INSTRUCTION MANUAL ADDENDUM

| PUBLICATION NO.: PM — 0700 | DATE OF ISSUE: 20 September 1968 |
| MODEL: RF-301 | CHANGES EFFECTIVE: 2694-2723 only |

The above listed RF-301 SSB Transceivers have been modified to provide an external keyline output signal (ground in transmit) and a external operate mode (+12 vdc for all operate modes of the RF-301) signal. The modification consists of the addition of a terminal board to the rear panel of the unit, above REMOTE connector J3, an added capacitor, and interconnecting wiring. The diagram below shows the modification schematically.

Pg. 8-9/8-10, Schematic Diagram, 162-0500.....

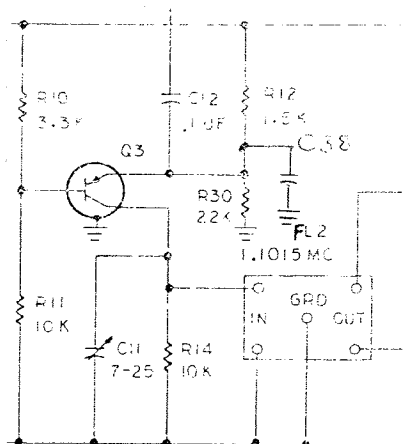
Add: C38 .005uF

Show C38 added at the junction of R12 and R30 as
shown below:

Pg. 8-23/8-24, Schematic Diagram.....

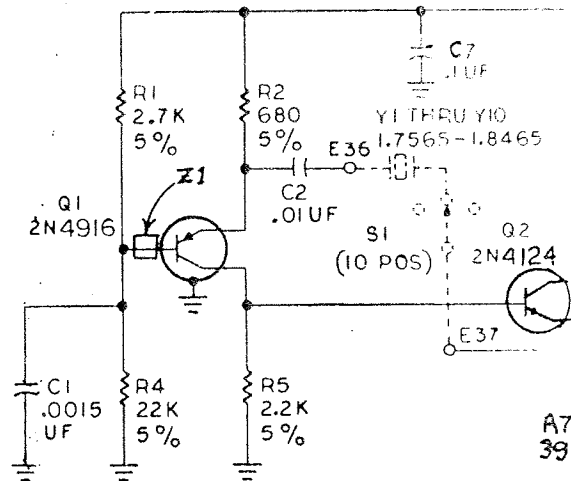
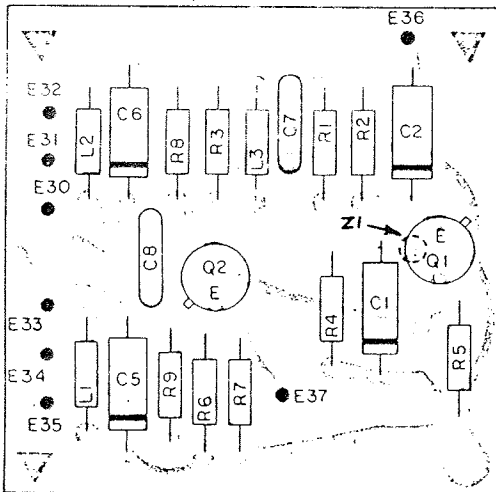
Add: Z1 Ferrite Bead

Show Z1 added to base lead of Q1 as shown
 below:

Page 8-33/8-34, Schematic Diagram, Main Frame Assembly.....

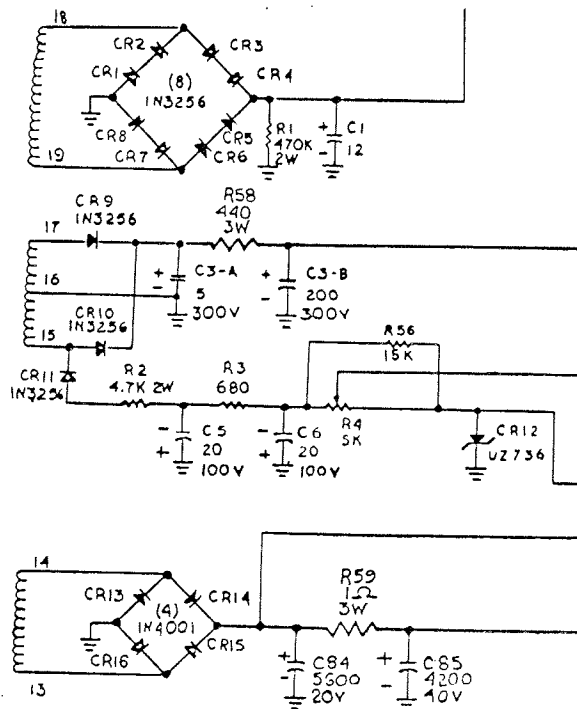
Change: C3-C to C84 (5600uF; 20V) and C3-D to C85 (5600uF 20V). See diagram.

Delete: C2, C11, C56, C58, and R17

L4-A, L4-B, and L4-C and show R58 removed from transformer T1 (terminal 16 and ground) and reconnected in place of L4-C (positive terminal of C3-A to positive terminal of C3-B). Change value of R58 to 440 ohms 3W.

Add: Resistor R59 (1 ohm; 3W) as shown in diagram below:
